ENVIRONMENTAL BOARD REGULAR MEETING MINUTES WEDNESDAY, July 16, 2008

NAME & NUMBER OF PROJECT: Austin Del Valle Motorcross Park
SP-2007-0613D

MEMORANDUM

SUBJECT: Austin Del Valle Motorcross Park/ SP-2007-0613D
14600 Pearce Lane

Figure 2. EII sample sites and Motocross location in the Dry Creek (east) watershed.

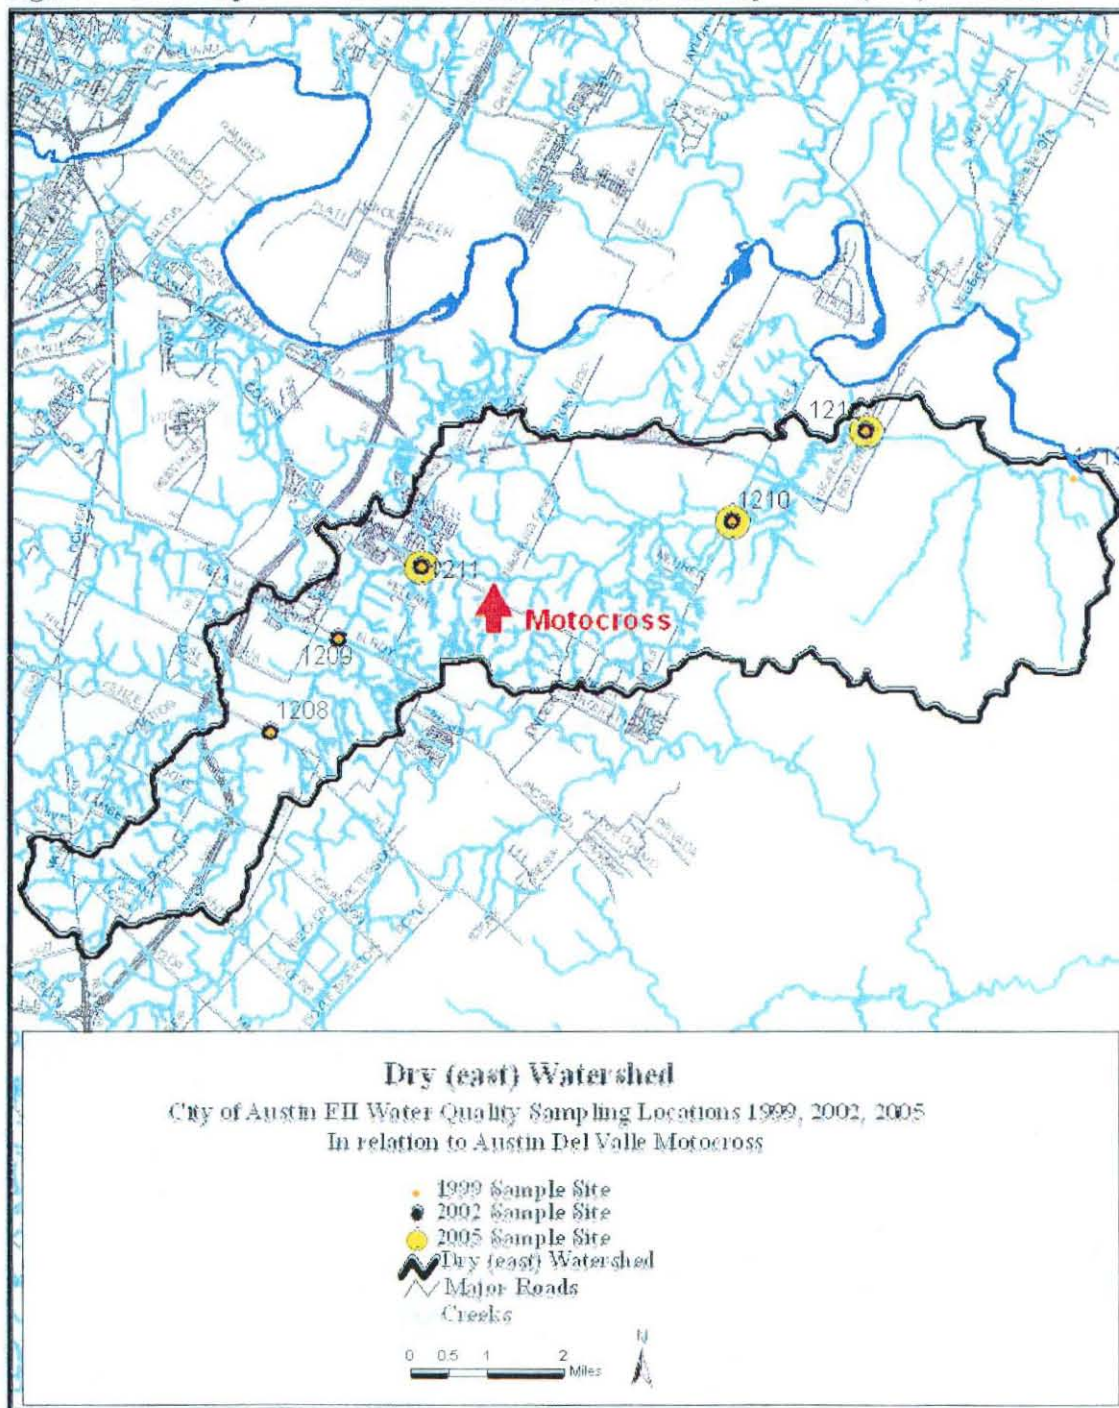
The Austin Del Valle Motocross is located in the Dry Creek (east watershed). The mainstem of Dry Creek is located in the northern edge of the tract, and two tributaries cross the property. The natural drainage patterns and floodplain has been modified by construction related to the racetrack. As shown by Figure 1 (2006 aerial photography with an overlay of a GIS'ed creeks) the Austin Dell Valle Motocross bare dirt racetrack has been constructed over tributary drainages of Dry Creek and alongside the Dry Creek banks. Field reconnaissance in early 2008 showed wetlands located within the blocked drainage ways in addition to flow paths which carry sediment from the racetrack.

Baseflow surface water of Dry Creek (east) is monitored through the Environmental Integrity Index program on a three year rotating basis. Six sites were monitored in 1999, five sites were monitored in 2002 and three sites were monitored in 2005, as shown in Figure 2. The Austin Motocross property is located on Dry Creek between sites 1211 and 1210. Site 1211 is upstream of the property and site 1210 is located downstream.

Figure 3

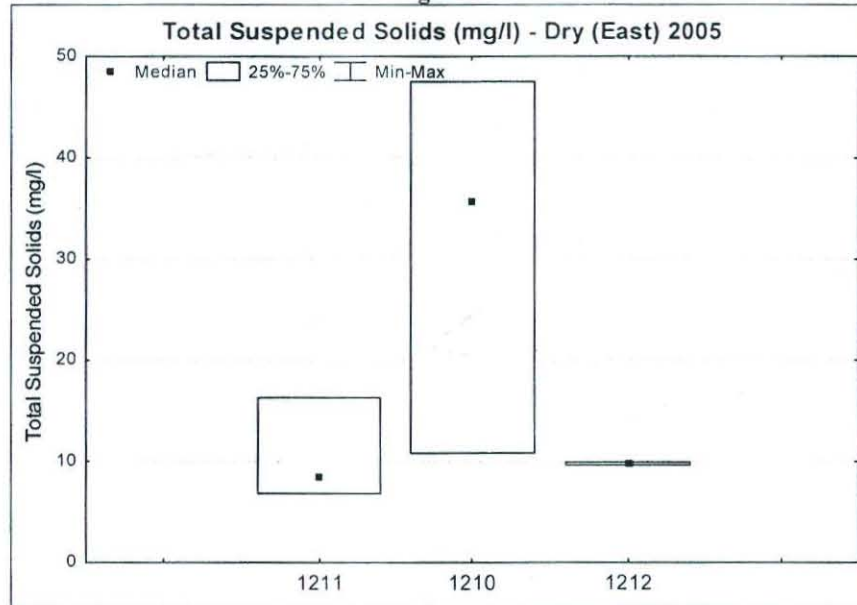
As shown by the results of Total Suspended Solids (TSS) and Turbidity from 2005 EII data, there is an increasing trend in both TSS and turbidity from the upstream EII site #1211 to the downstream EII site #1210 (Figure 3 and 4). The mouth site #1212 was typically dry due to surfacewater baseflow infiltrating into the alluvial channel deposits, therefore not much data is available.

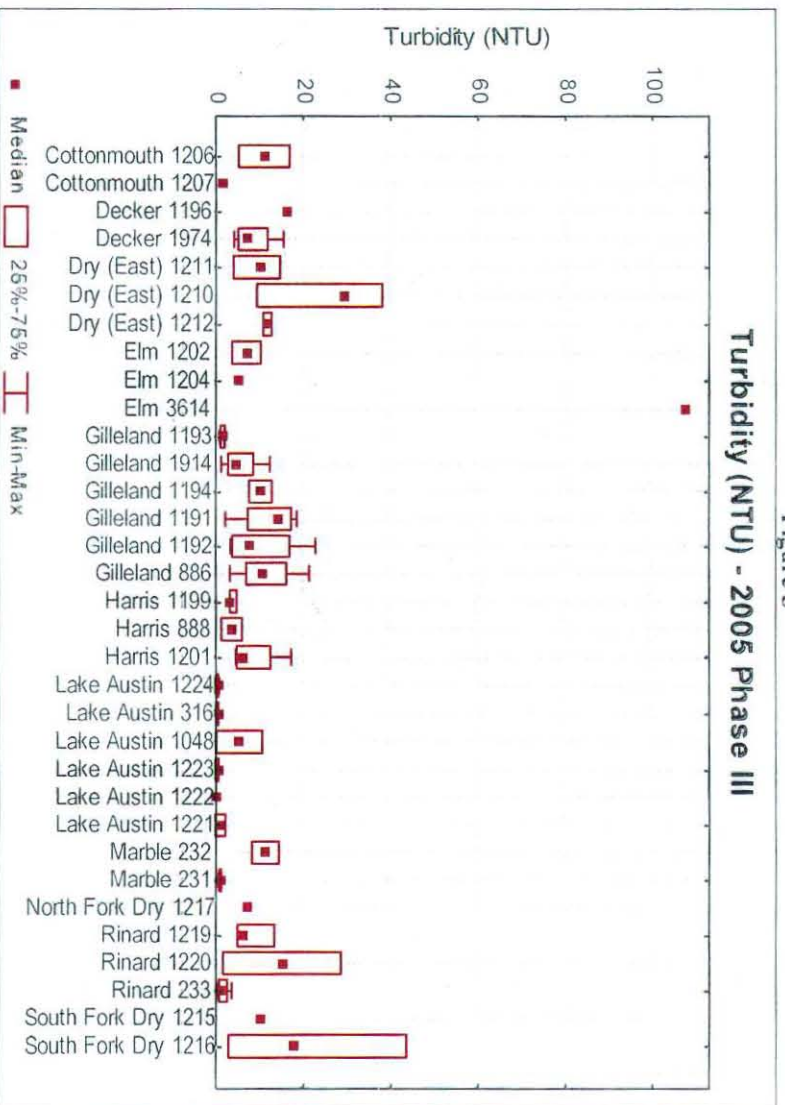
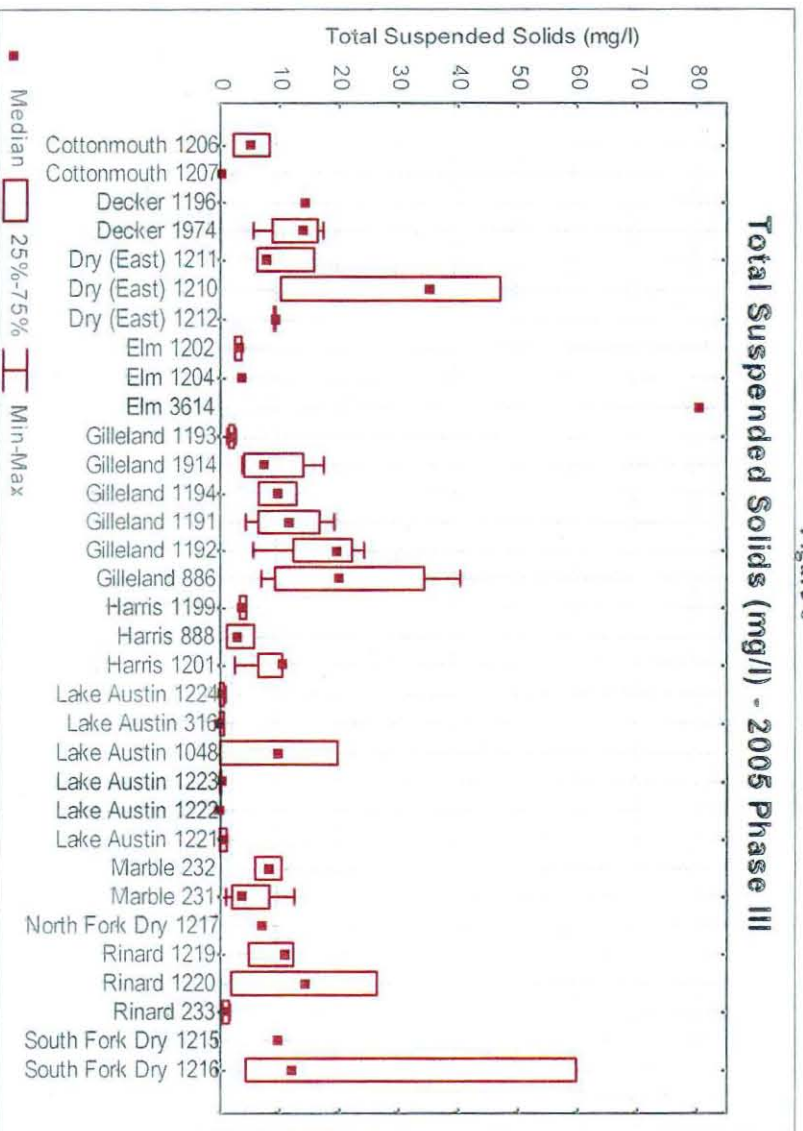
Figures 5 and 6 show the results of TSS and turbidity from site 1210 in the context of the surface water results from all watersheds during the 2005 EII sampling events. As can be seen, the concentrations recorded for site 1210 were higher than most.
